Proposed Cycle Entrance through the existing pond and route around the Proposed TP2 Ground Floor Level 1:500

LEGEND (ALL CHANGES TO ALL LEVELS)

Ground floor level plan

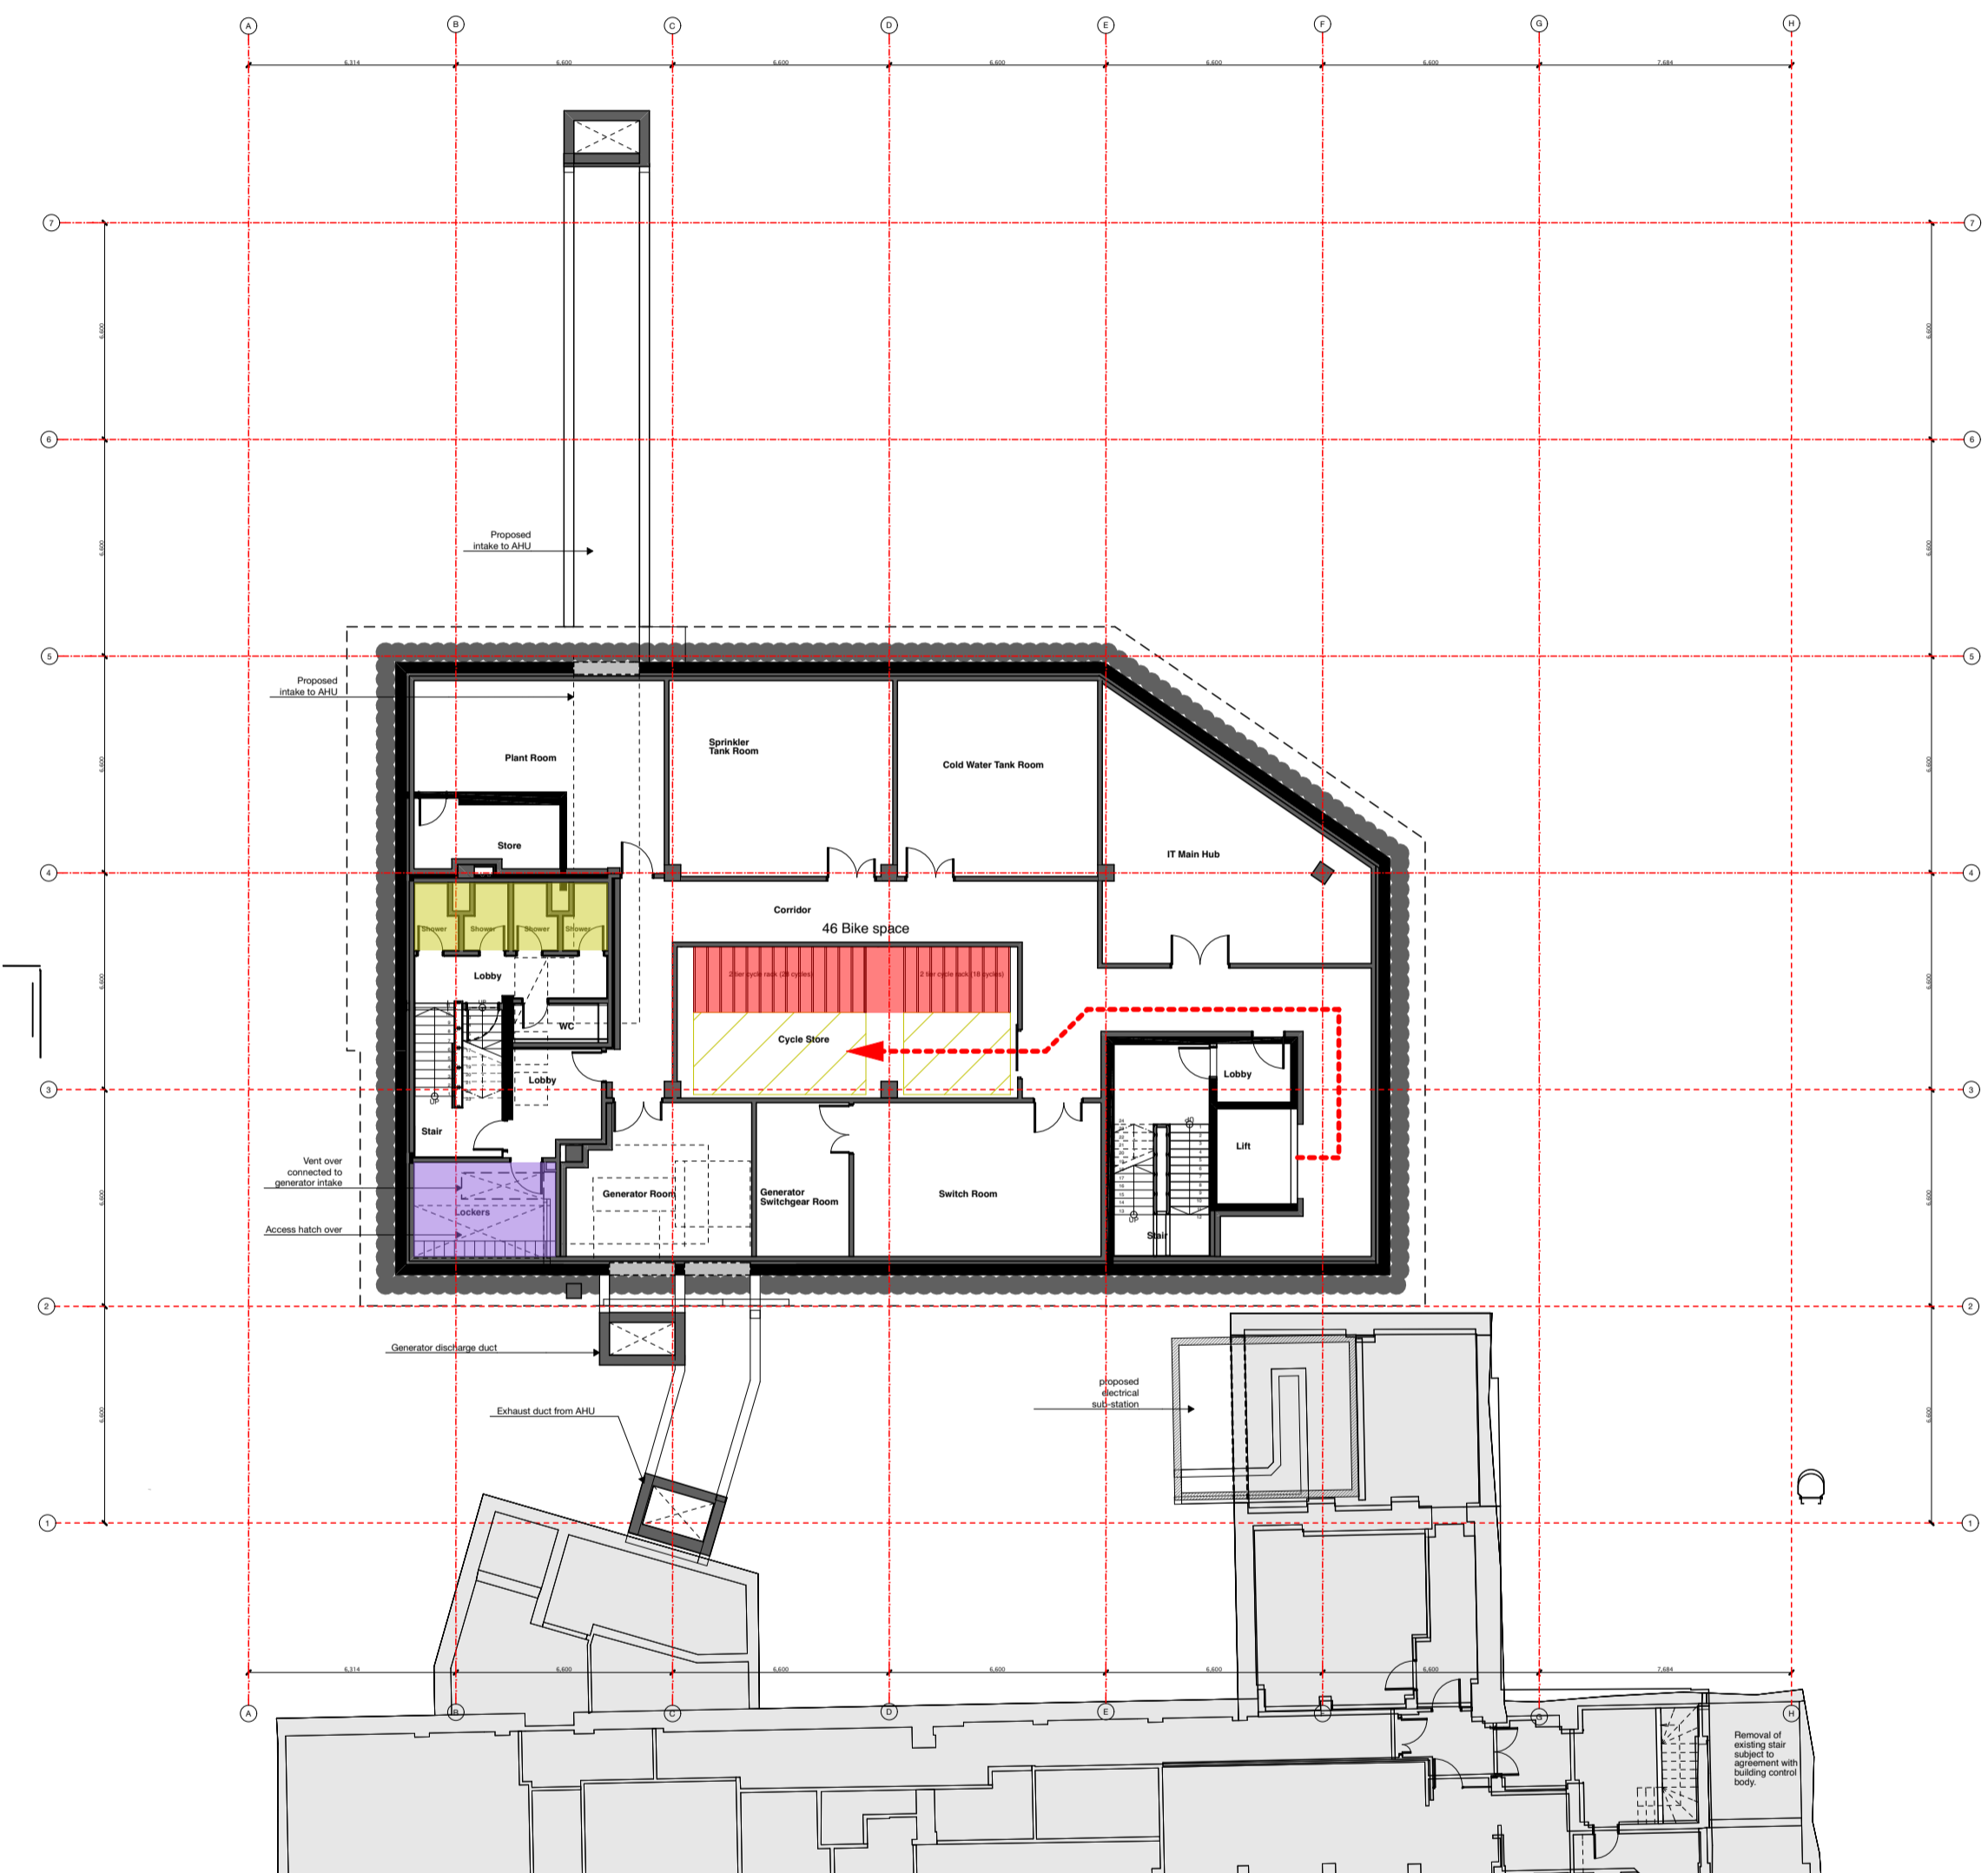
| <ul style="list-style-type: none"> ▲1. Stair 2 omitted, and glazed entrance enclosure enlarged ▲2. Window added ▲3. New steps to base of external spiral stair ▲4. Stair 3 roof and gable end arrangement revised. ▲5. Level 3 accommodation mansarded ▲6. Roof light size, height and position adjusted, and smoke vents added. ▲7. Louvres omitted. ▲8. Roof light size, height and position adjusted. | <ul style="list-style-type: none"> ▲9. External ramp adjusted, and railings added. ▲10. West stair core glazing fenestration adjusted to suit amended stair landing levels. ▲11. External paving levels in courtyard raised to achieve required paving falls. ▲12. Low brick plinth added to base of external walls to TP2. ▲13. External levels adjusted ▲14. Brick plinth added to base of existing buildings within courtyard. ▲15. New steps and landing outside room G1. ▲16. Bin store enlarged and repositioned. ▲17. Gallery passageway to TP2: finishes revised. ▲18. Gallery passageway; entrance gates design revised. | <ul style="list-style-type: none"> ▲19. Window on north elevation of TP2 reduced in length. ▲20. Revised turn-table size and position ▲21. Entrance ramp gradient and levels adjusted. ▲22. TP1 west door ramp omitted ▲23. Fall restraint added ▲24. Gates removed ▲25. Maintenance access door added ▲26. Parapet revised ▲27. Roof/wall shape adjusted ▲28. TP1 reception relocated | <ul style="list-style-type: none"> ▲29. Revised door design ▲30. Modifications to windows, doors and facades facing into courtyard. ▲31. Gate details revised ▲32. Revised proposal for bike storage replacing existing bike racks in Dairy shed. ▲33. Gate retained and modified ▲34. Bike canopy detail revised (typical condition highlighted) ▲35. Sub-station doors revised ▲36. Steps adjusted ▲37. Cladding changed to brass finish ▲38. Wall mounted planters revised (typical condition highlighted) ▲39. Steel posts added to boundary wall (typical condition highlighted) | <ul style="list-style-type: none"> ▲40. Height of glazed entrance roof increased to suit required pitch. ▲41. Glazed entrance roof and canopy revised ▲42. New roof guarding to existing flat roof ▲43. Screening fins and cladding added ▲44. Louvres added ▲45. Ramp omitted ▲46. Door removed and infilled ▲47. Access hatch adjusted. ▲48. Depth of green/blue roof build-up adjusted. ▲49. Blue roof incorporated into green roof and gravel margins added. ▲50. Cladding build-up adjusted | <ul style="list-style-type: none"> ▲51. Orientation of brass seams adjusted ▲52. Roof gutters revised. ▲53. Means of escape revisited and exit door added to TP1 ▲54. Spiral staircase landings added at each floor ▲55. Door modified ▲56. Basement louvers to external metal staircase landings ▲57. Revised proposal for mean of escape in TP1 ▲58. Revised proposal for window and door ▲59. Revised proposal for door to be left as current ▲60. Gate to be removed ▲61. Capping width adjusted and roof planters shown indicatively. | <ul style="list-style-type: none"> ▲62. Door to be replaced ▲63. Revised proposal for the entrance ▲64. Gates and Entrance door in TP1 to be replaced ▲65. Existing stair to be demolished ▲66. Existing window and door to be replaced ▲67. New reconfiguration for new spiral stair and WC ▲68. Staircase partially demolished ▲69. Level adjusted ▲70. Lift pit adjusted ▲71. Level updated ▲72. Red line extended to include South Crescent Mews | <ul style="list-style-type: none"> ▲73. Red line extended to include new ramp and frontage ▲74. Ladder added ▲75. Works to Mews paving/kerbs added ▲76. Minor adjustment to ridge, and eaves line, (not affecting ridge level noted on consented drawings). |
